POST TENDER ADDENDUM No. 02

Smithers Regional Airport
Terminal Upgrade and Expansion
Smithers, BC Contract 2017-11
July 21th, 2017 MW #16-181

STRUCTURAL POST TENDER ADDENDUM NO. 1

Revisions to Structural Drawings as Issued for Tender dated 2017/04/11:

1 BUILDING SECTION - TYPE 3
S3.2 1 : 50

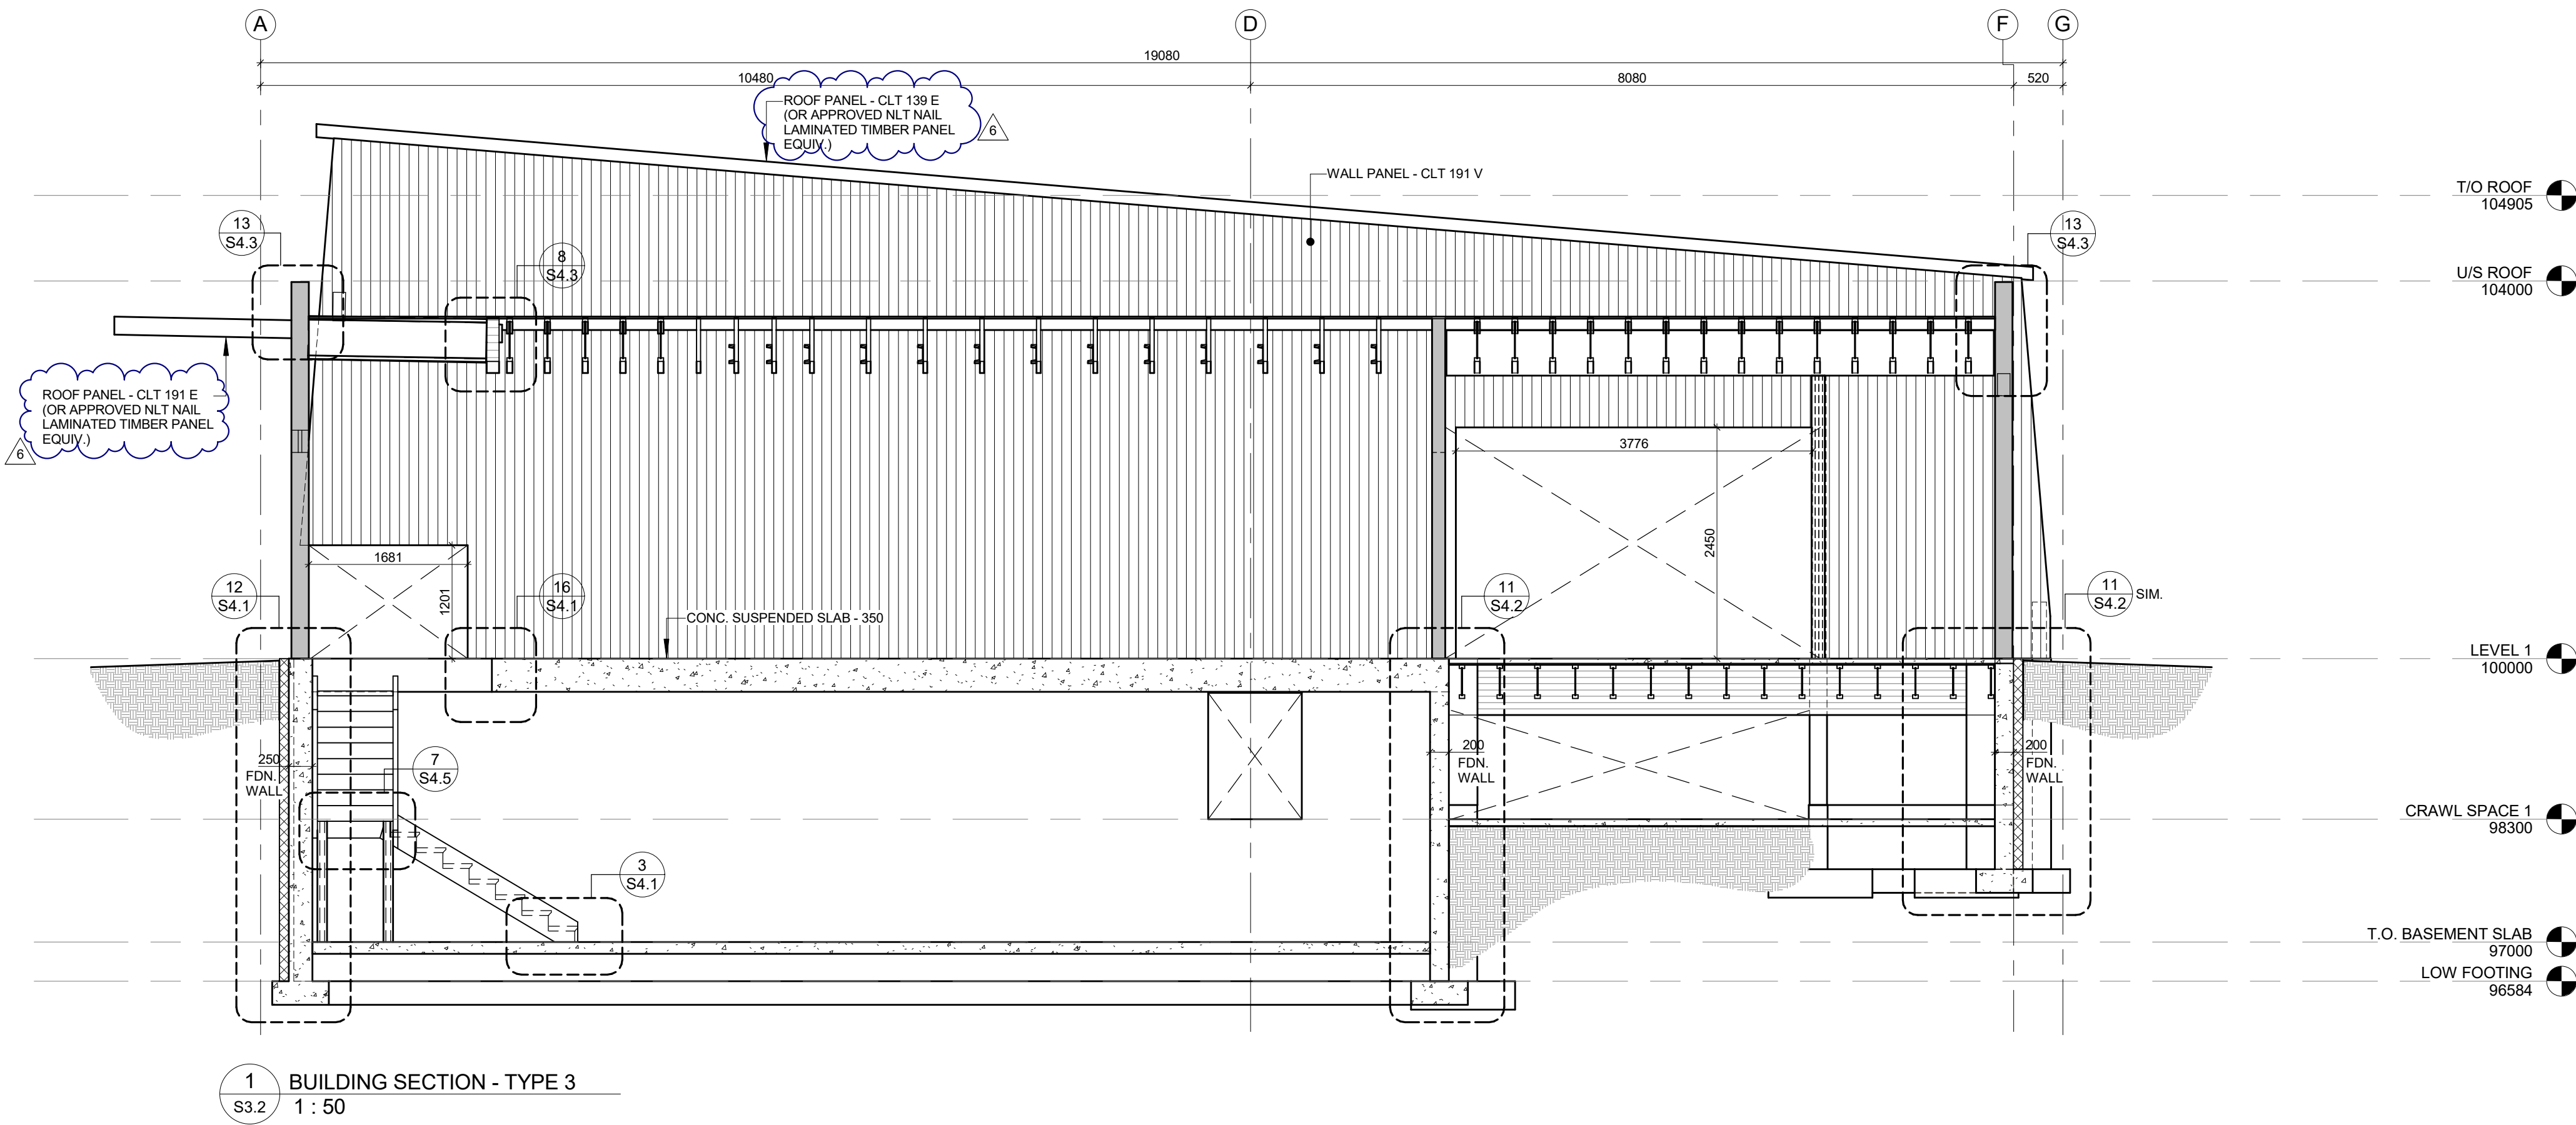
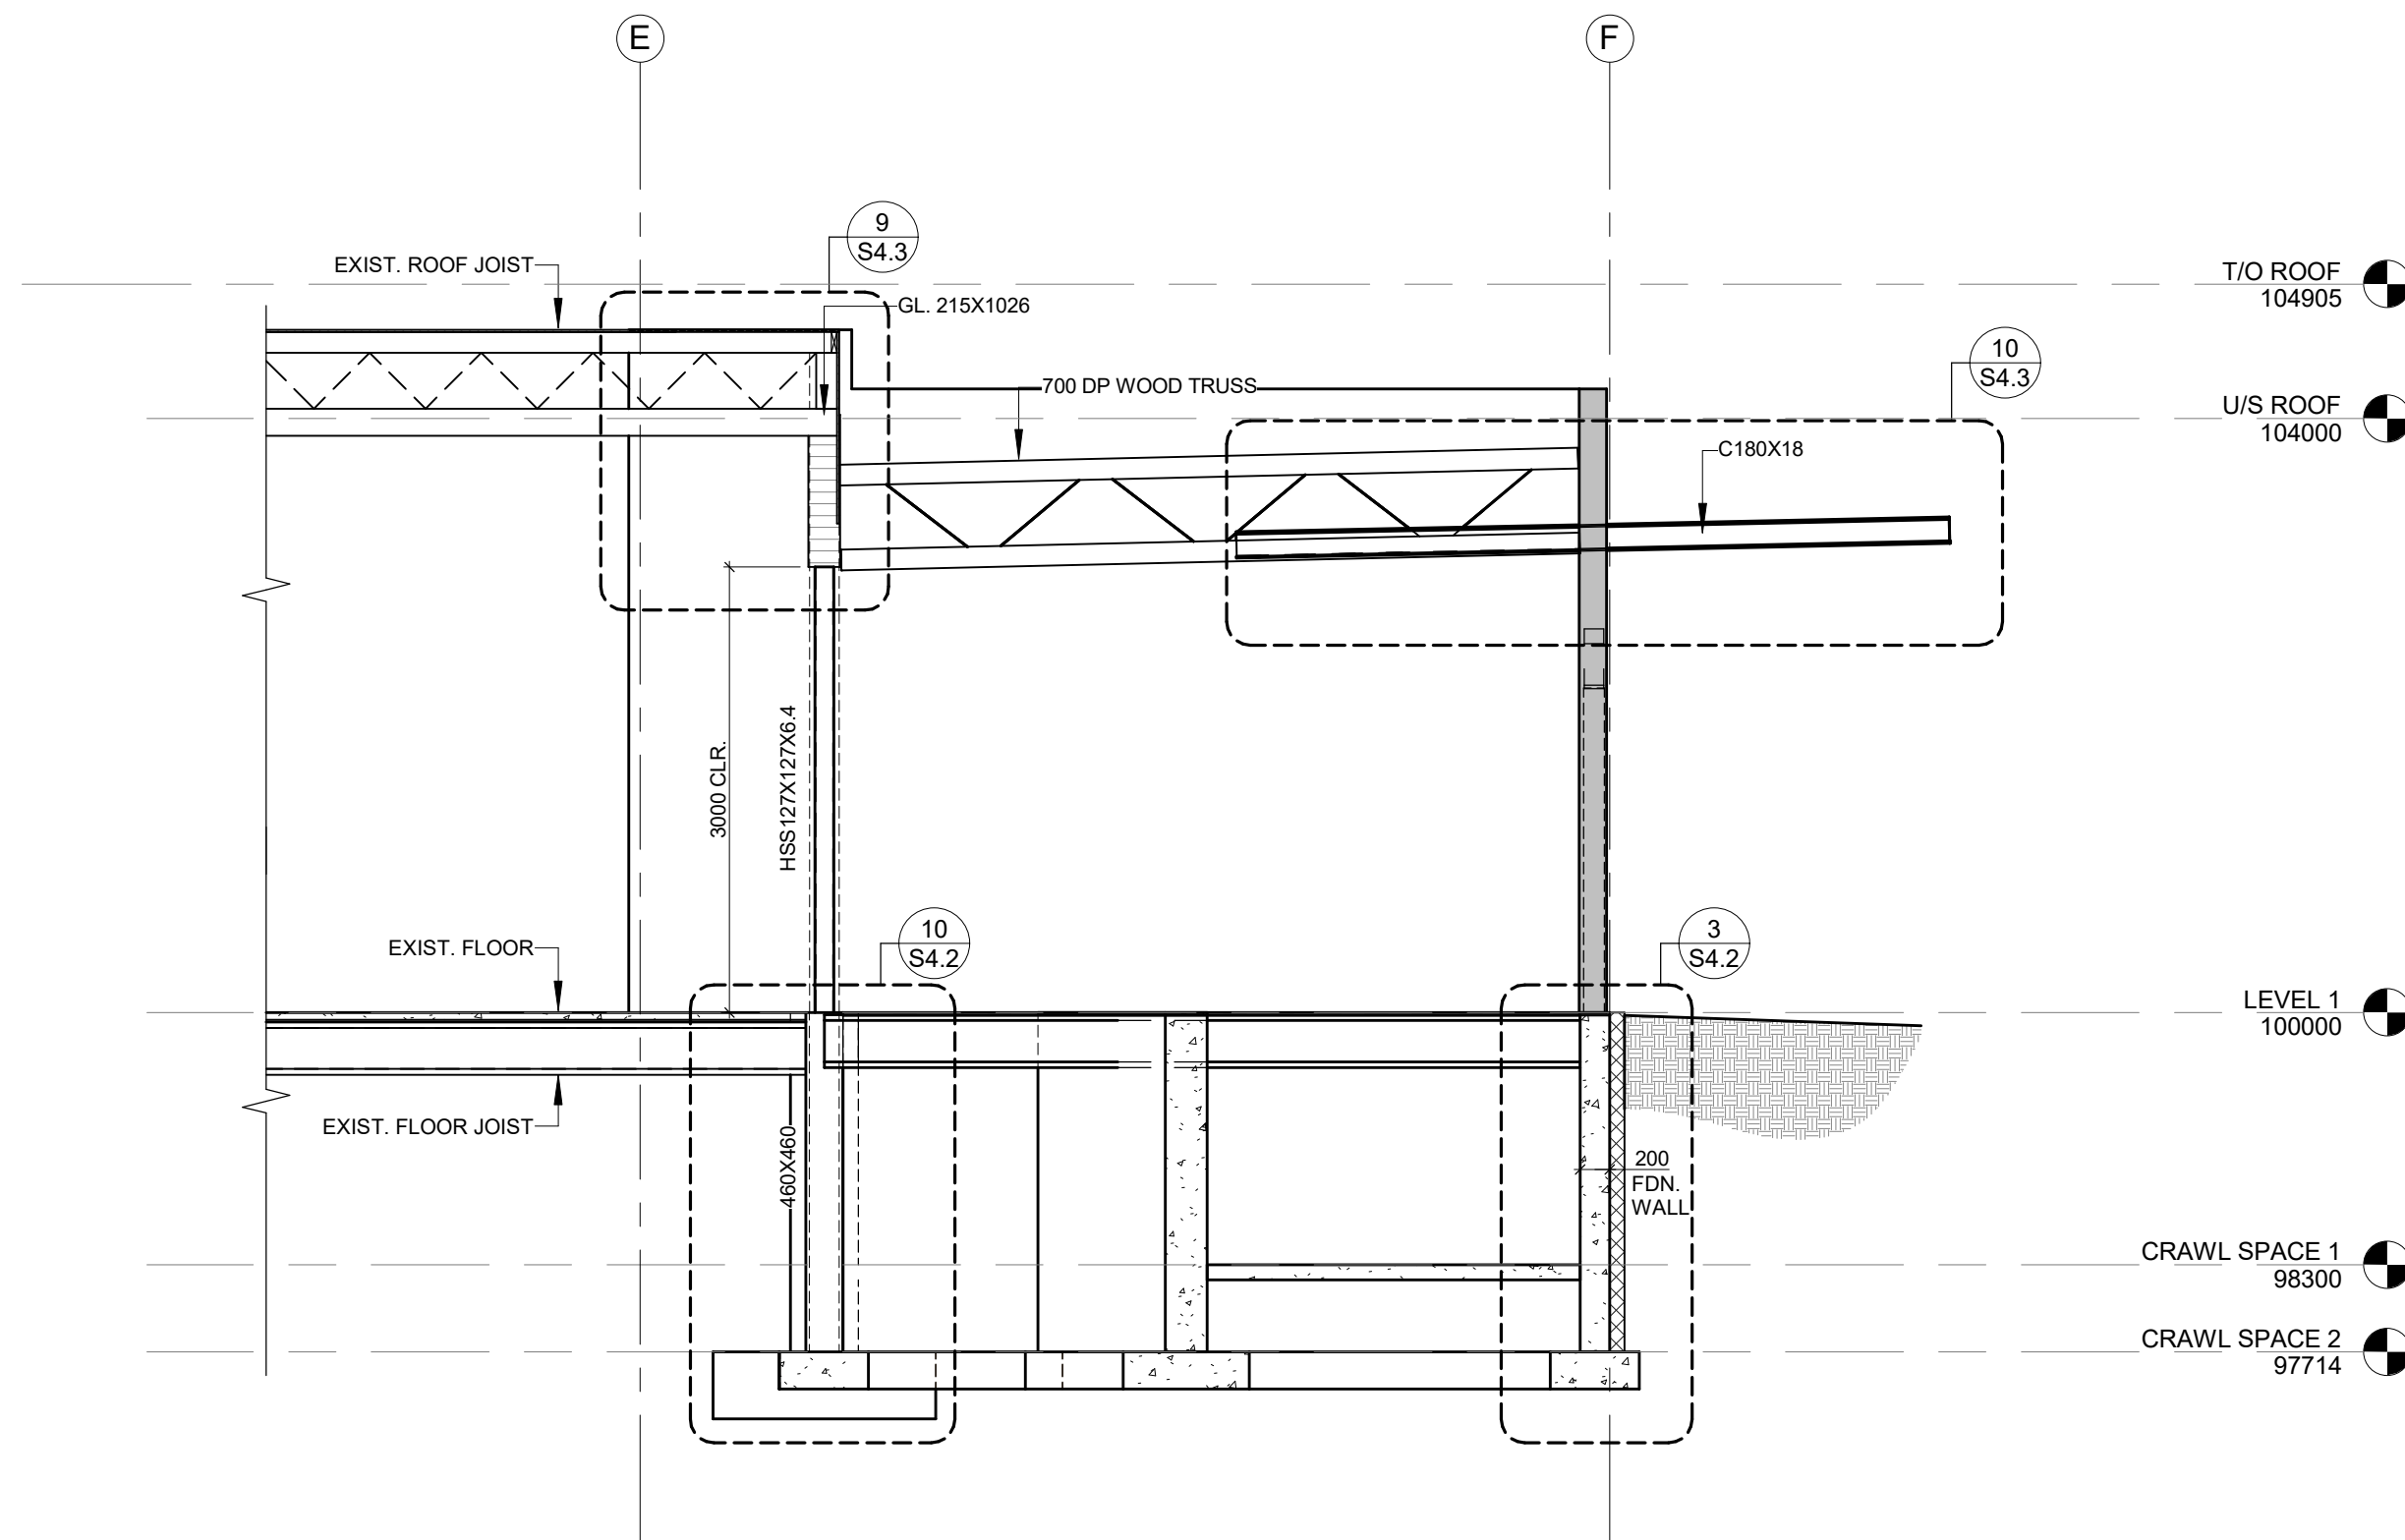
6. SHEET S3.2 – BUILDING SECTIONS (VPG ITEM #8)

- i. Revise** NLT Roof and Canopy panels can be used as an alternative for CLT Roof and Canopy panels – submit alternative design to Kerkhoff Engineering for approval
